Stage 03: Workgroup Report

GC0100 EU Connection Codes GB Implementation – Mod 1

This document contains the discussion of the Workgroup formed in June 2017, responses to their consultation and the Workgroup's final conclusions.

Figure 3.15(a) – GB Proposed Voltage Against Time Curve of a Type B Synchronous Power Generating Module showing the conflict with Stage 2 G59 Undervoltage Protection

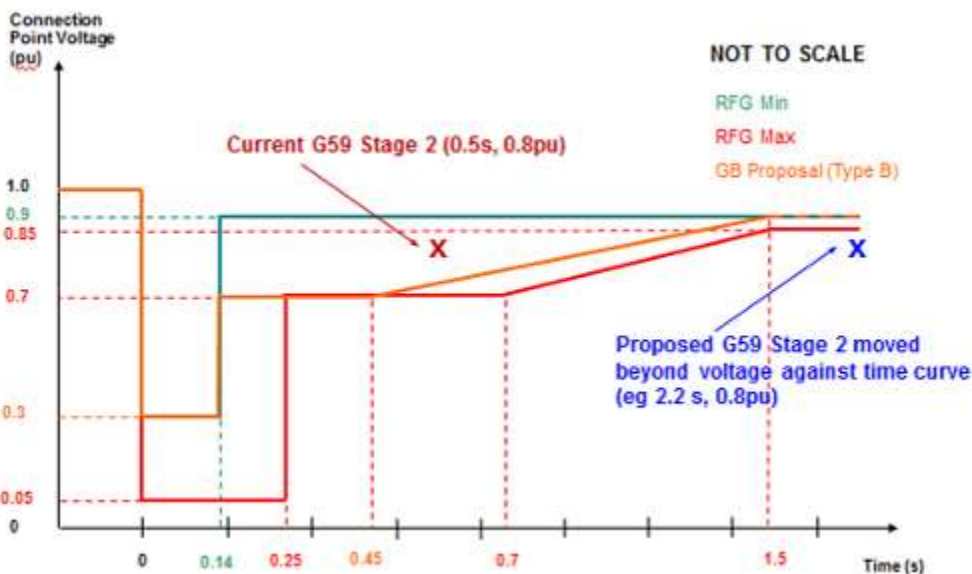
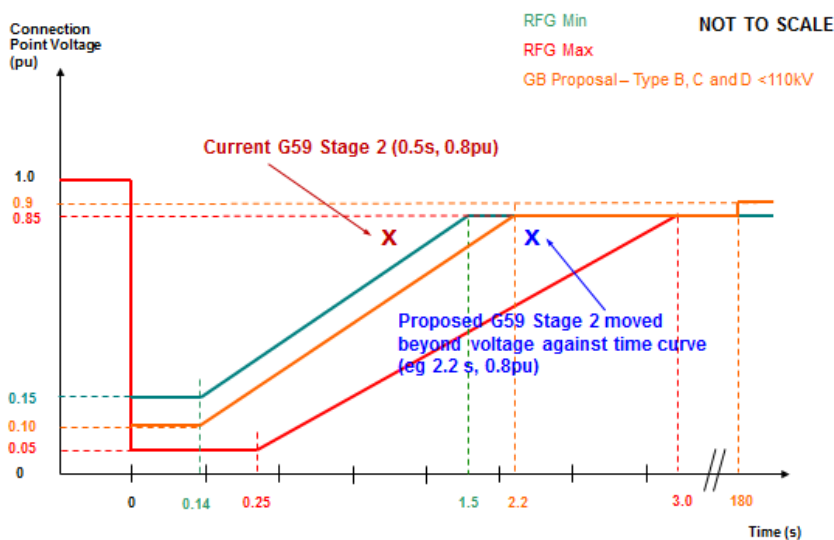
The proposed voltage against time curves for Type B – D Power Generating Modules are detailed above. For those Power Generating Modules which are connected to the Distribution Network, stakeholders noted that there would be a conflict with the G59 under voltage Stage 2 protection which is currently set at 0.8pu for 500ms. Whilst this was marginal in the case of the voltage against time curve for Synchronous Power Generating Modules it was more severe in the case of Power Park Modules where even the minimum RfG voltage against time criteria would have been incompatible with the current G59 Stage 2 under-voltage protection settings.

These issues are shown in Figures 3.15(a) and 3.15(b).

The Workgroup discussed this and The Proposer decided that the best policy for their original solution would be to move the G59 Stage 2 undervoltage protection to 0.8pu at 2.5s. This requirement would apply to all new connecting plant and would be equally applicable to Synchronous Power Generating Modules and Power Park Modules.

It was not believed that changing the G59 Stage 2 Undervoltage protection would cause a significant problem however it was included as a consultation question. The Grid Code/Distribution Code workgroups GC0035 and GC0079 continue to investigate the issues associated with changing RoCoF protection settings for distribution connected generators and have undertaken a risk assessment of Distribution system protection requirements. The analysis for this has been performed by the University of Strathclyde.

Figure 4.1 (a) Effect of Fast Fault Current Injection Option 2 on clearance time

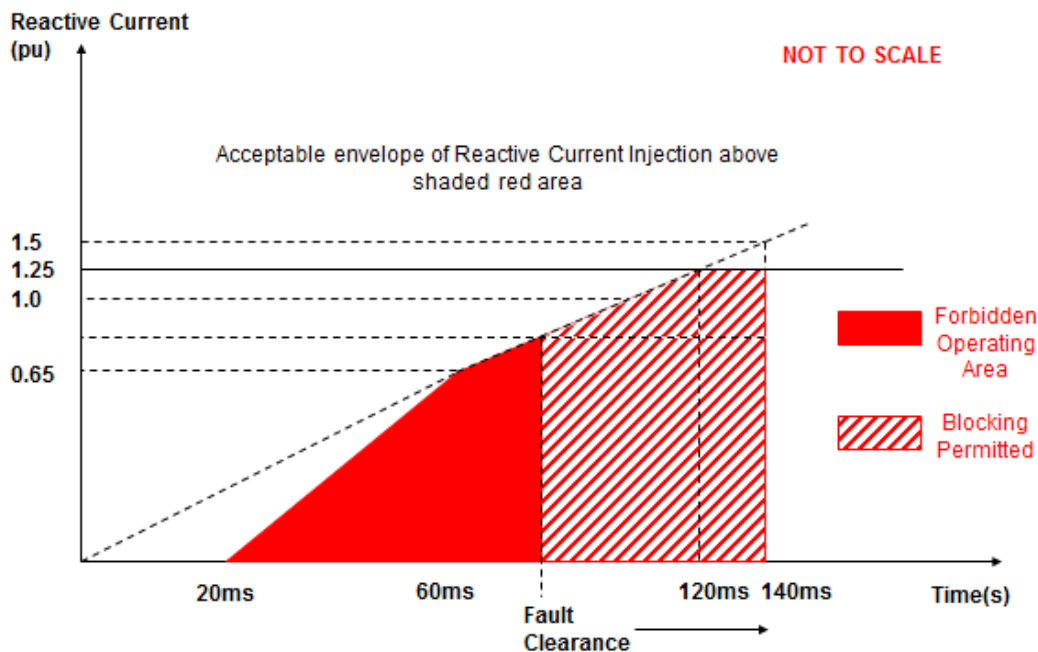
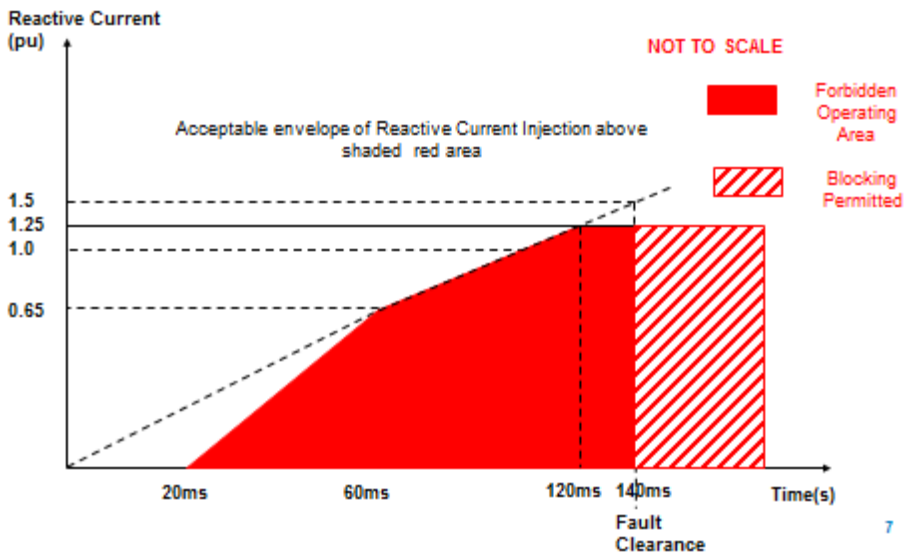
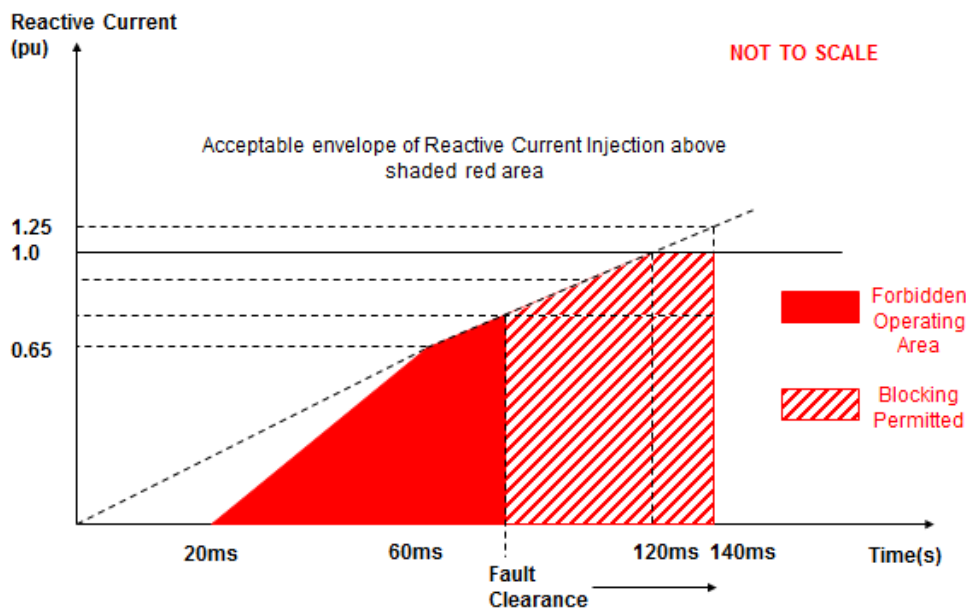
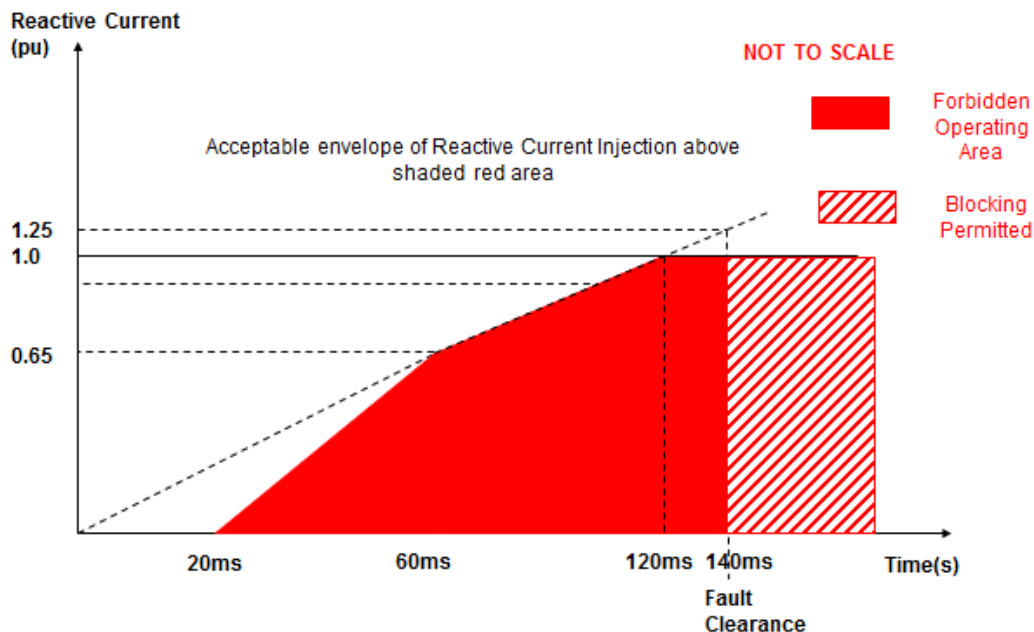
Option 2 requires a minimum volume of reactive current injection as shown in Figure 4.1(a) and (b). Blocking is permitted on fault clearance to prevent the risk of transient overvoltages). This option would apply to all New Type B and above Power Park Modules which had not signed their contract for major plant items by 17 May 2018 or HVDC Owners who had not signed their contract for major plant items by September 2018.

Option 3 is a duplicate of Option 2 above but the maximum ceiling current would be limited to 1.0pu as shown in Figure 4.2(a) and 4.2(b). This option would apply to all New Type B and above Power Park Modules which had not signed their contract for major plant items by 17 May 2018 or HVDC Owners who had not signed their contract for major plant items by September 2018.

Please note that following the Workgroup Consultation the Proposer has clarified that **Option 3** is their proposed solution which is reflected in the legal text in Annex 1.
